ADDENDUM No. 1

RFP No. 23-10

Research Park Drive Resurfacing Project

REV. NO.	DATE	DRAWN BY	CHECKED BY
SPECIAL STRUCTURE COVER STORM			
DR. ENG	CH. ENG	DRAWING NO.	
SCALE N.T.S.	DATE 11/1/2022	SD-GU-3

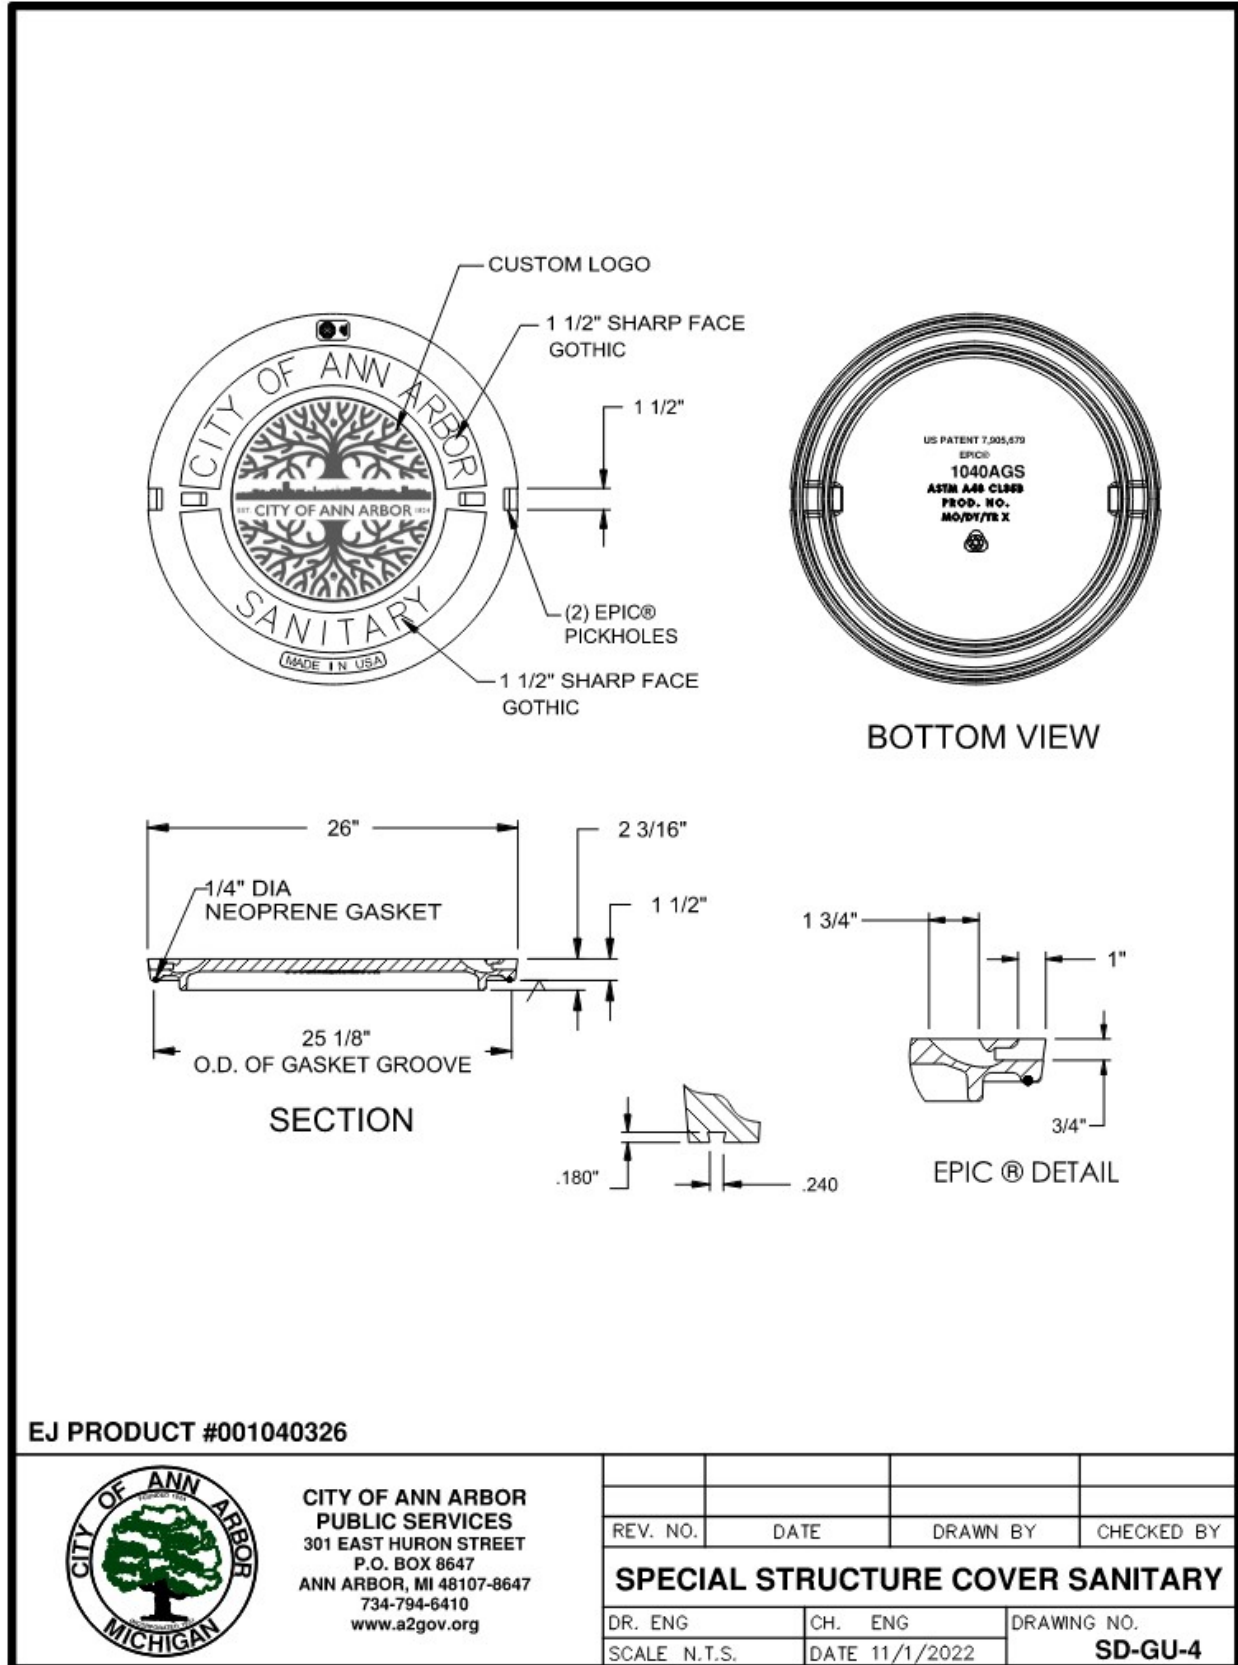
Schedule of Pricing/Cost Forms; replace with pages Addendum-1-4 to 8. Added pay item 4037050 - _Dr Structure Cover, Type Q, Modified.

EXISTING RESEARCH PARK DR TYPICAL SECTION

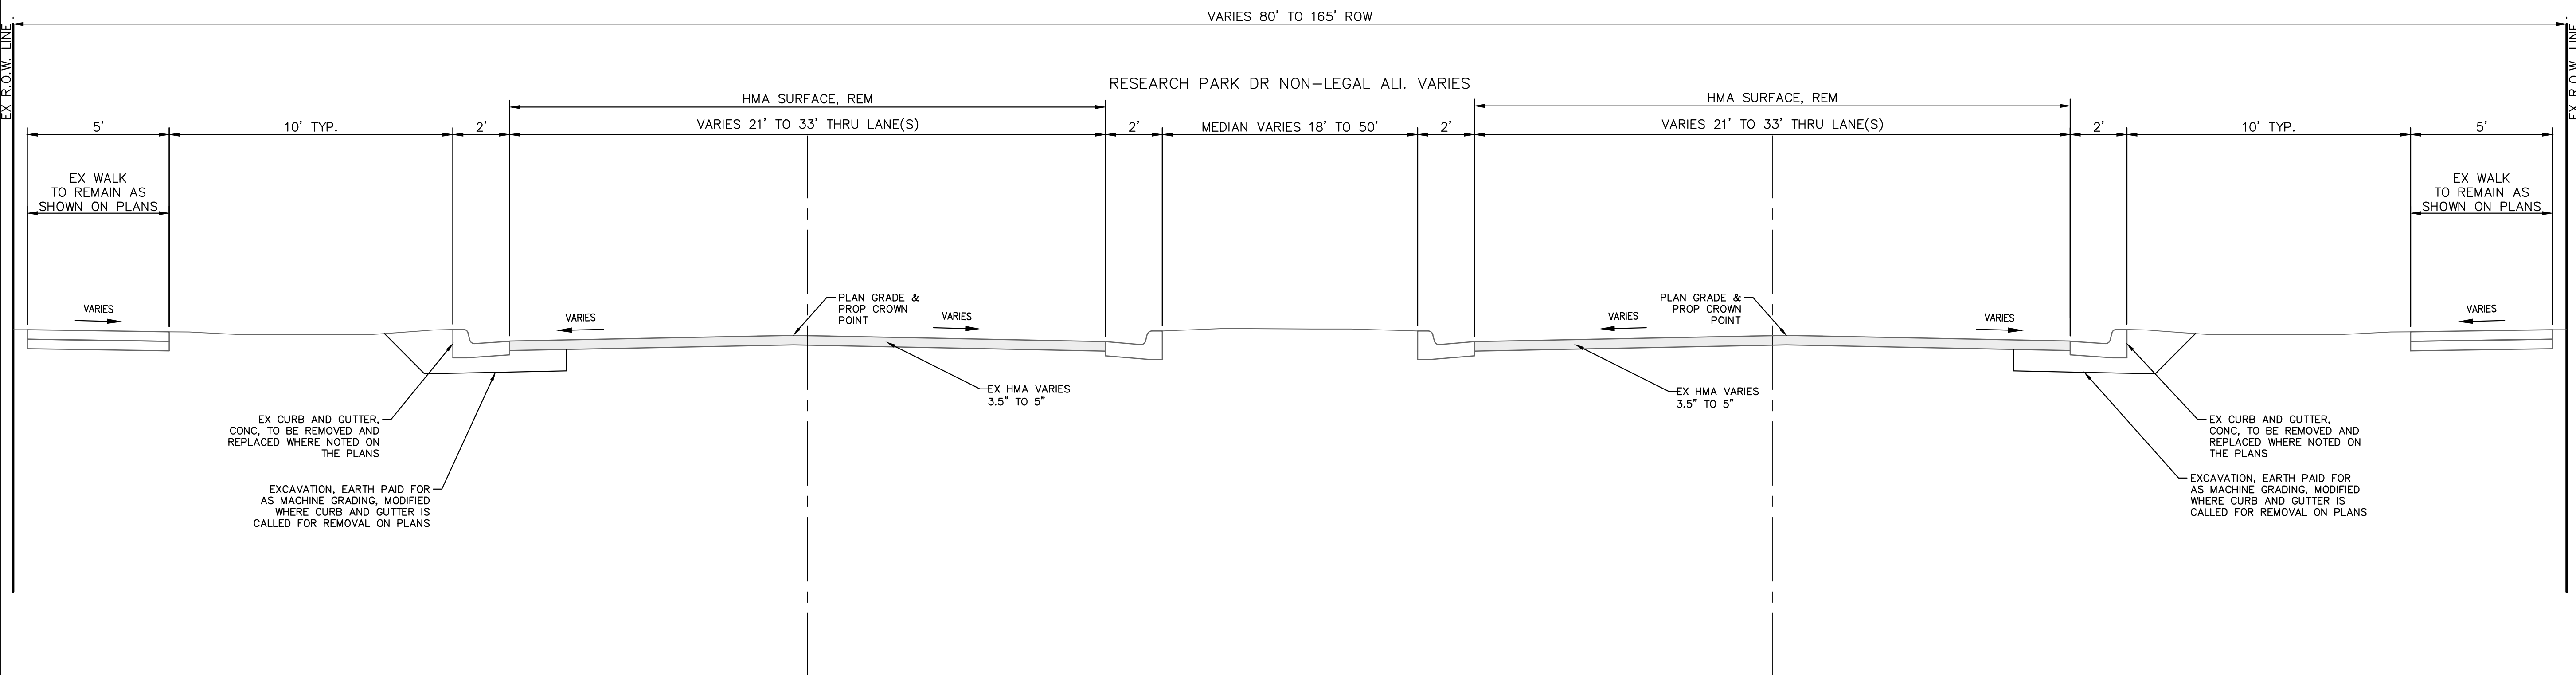
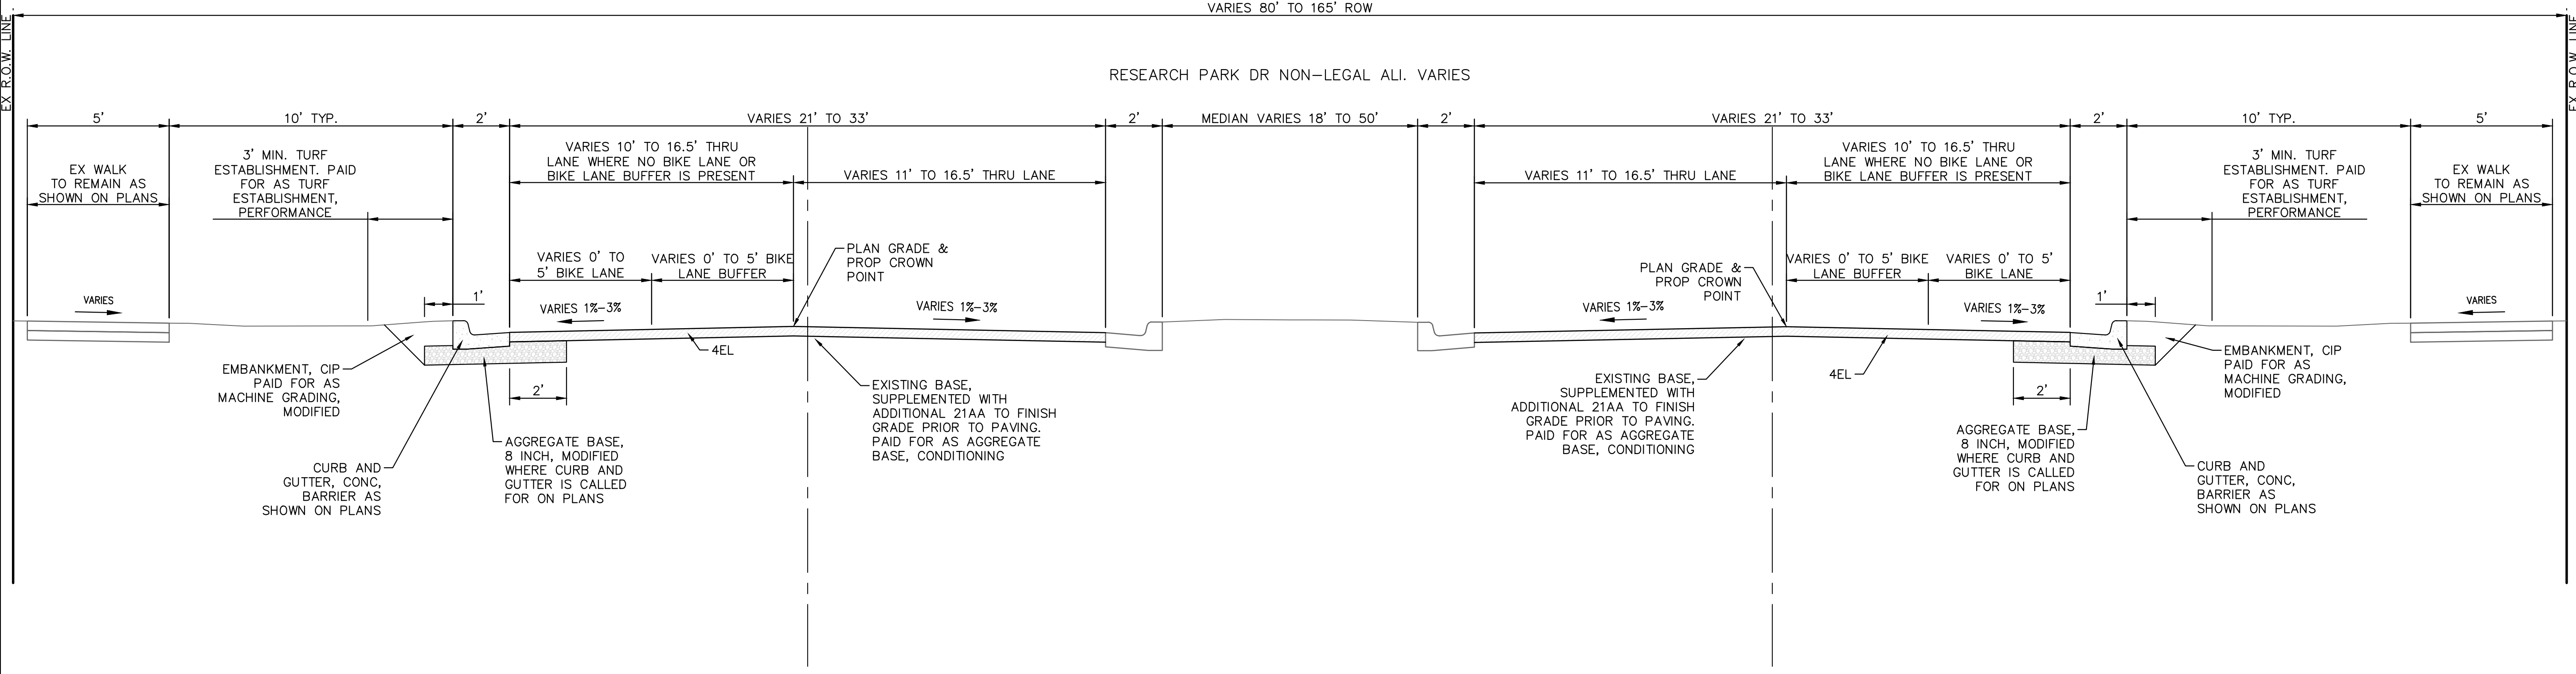
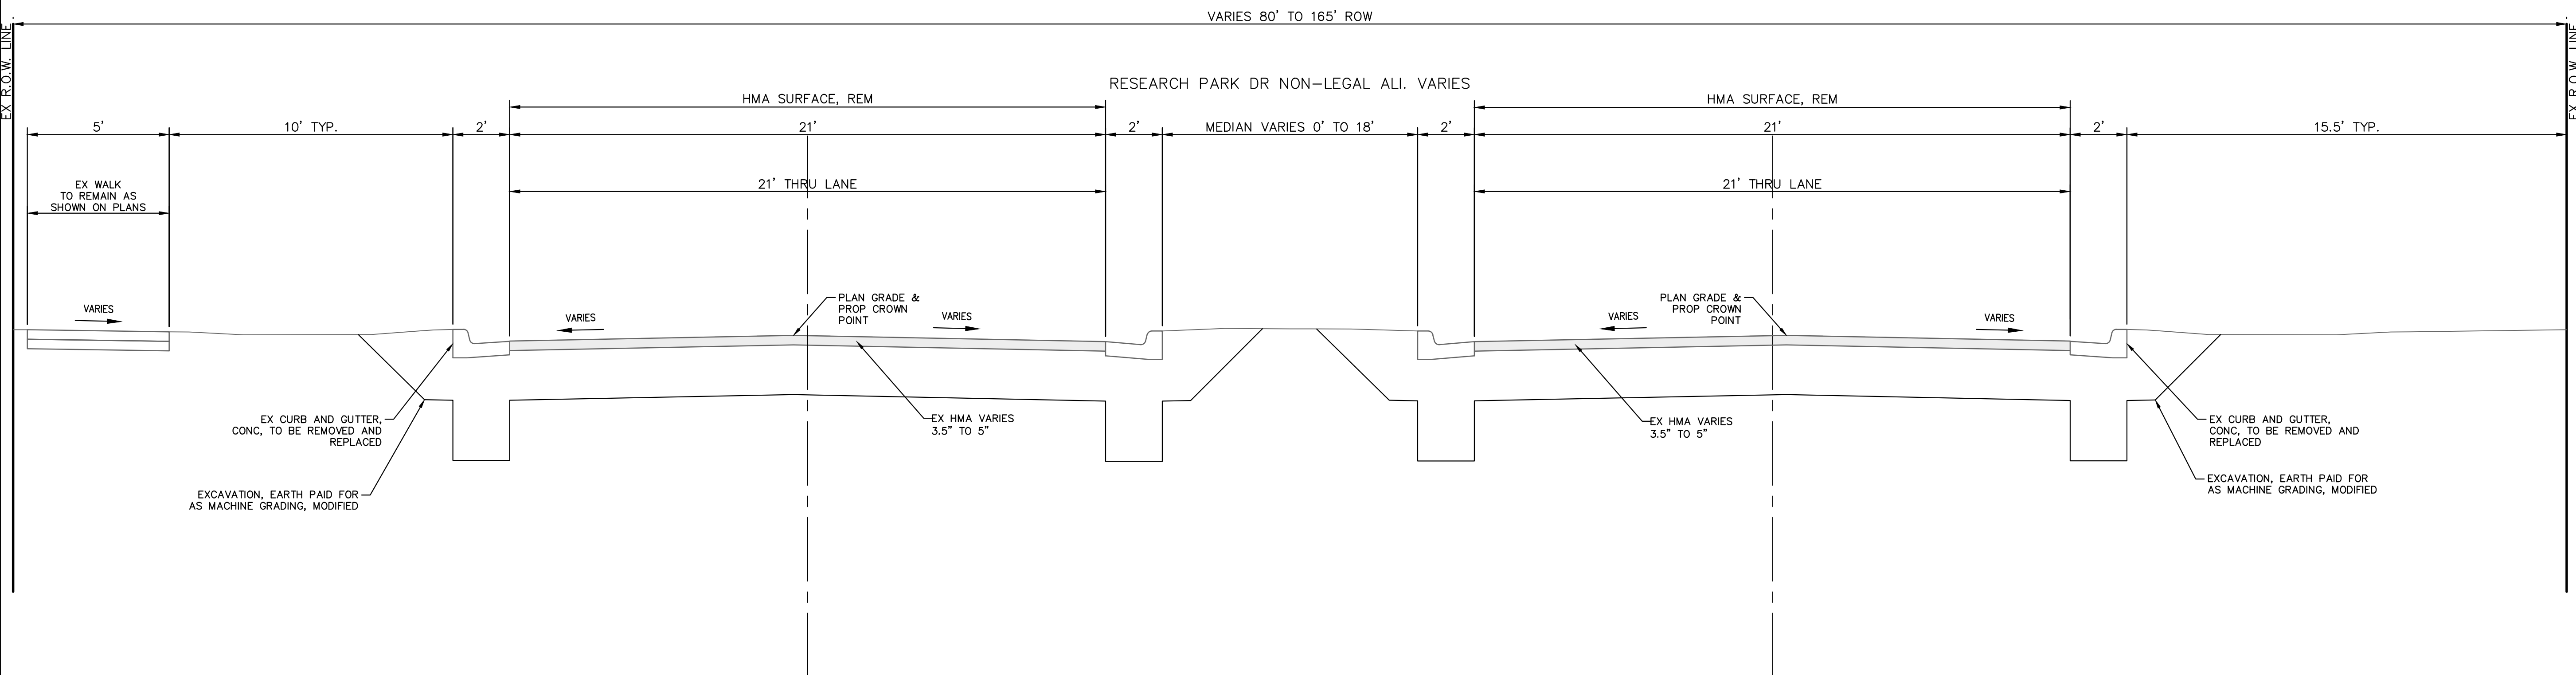
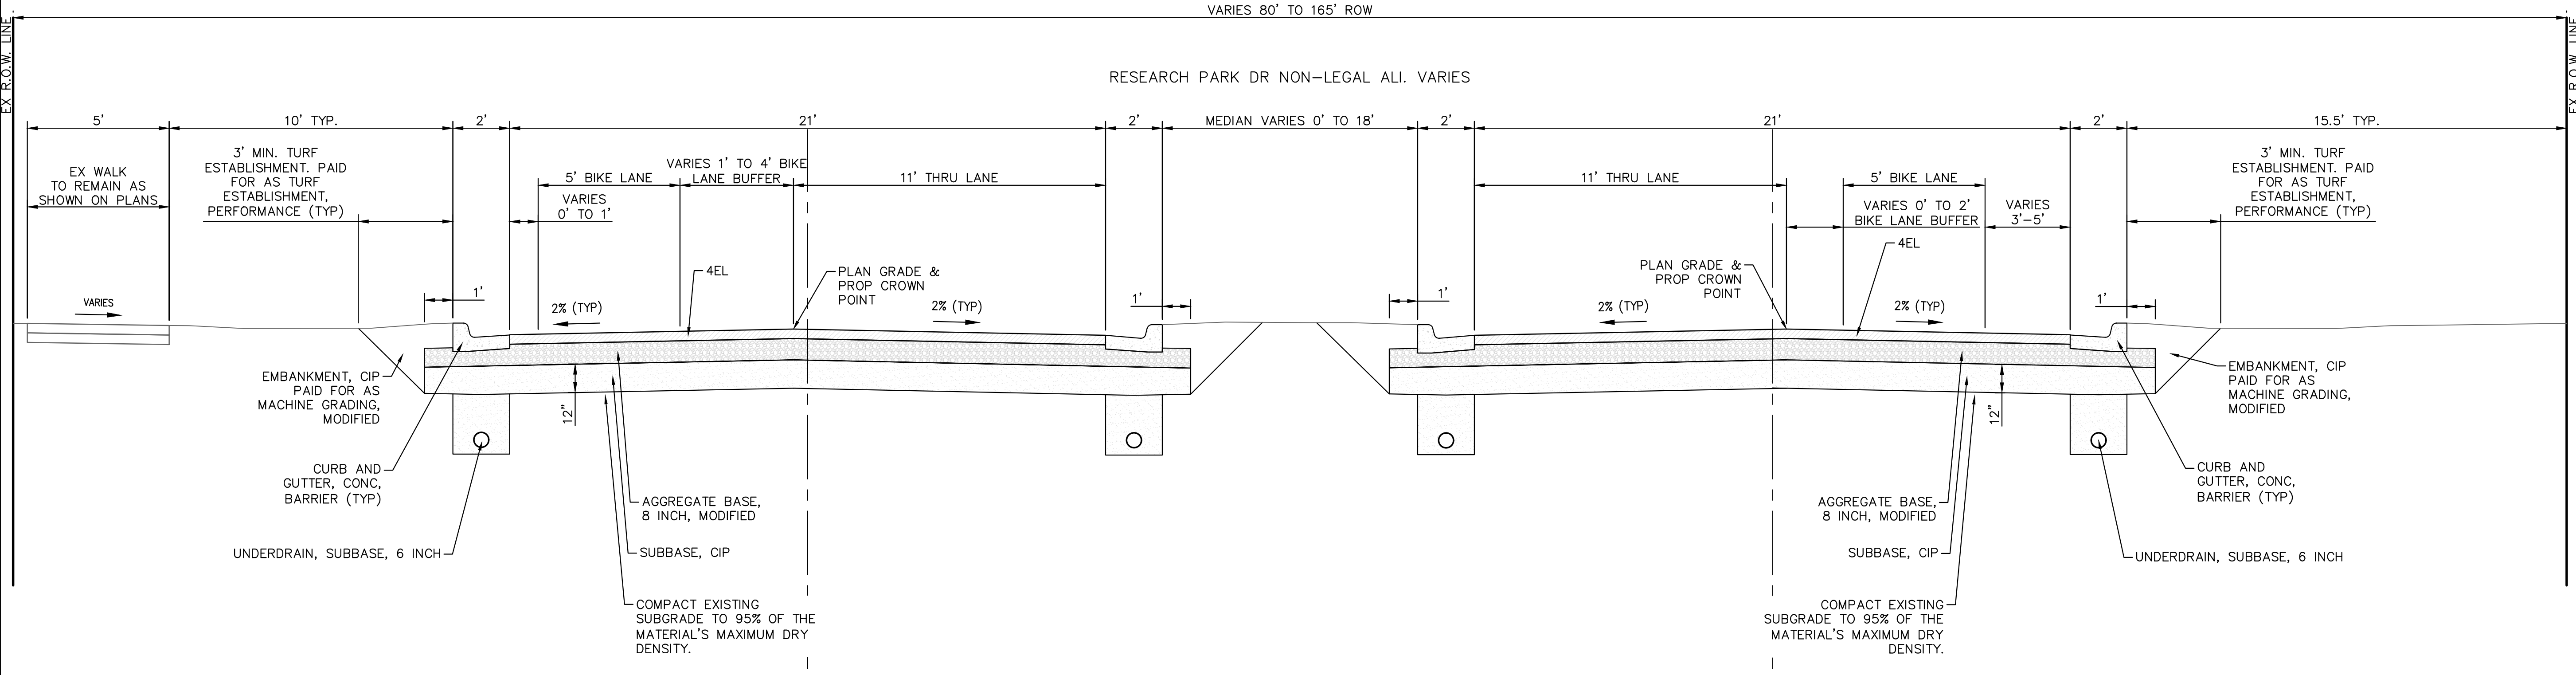
Sheet 9	Revised call outs on proposed typical section related to hot mix asphalt leveling and top courses. Revised HMA Application Table
Sheets 10-13	Revised call outs on proposed typical sections related to hot mix asphalt leveling and top courses.
Sheets 20-27	Revised call outs related to storm structure covers and adjustments.
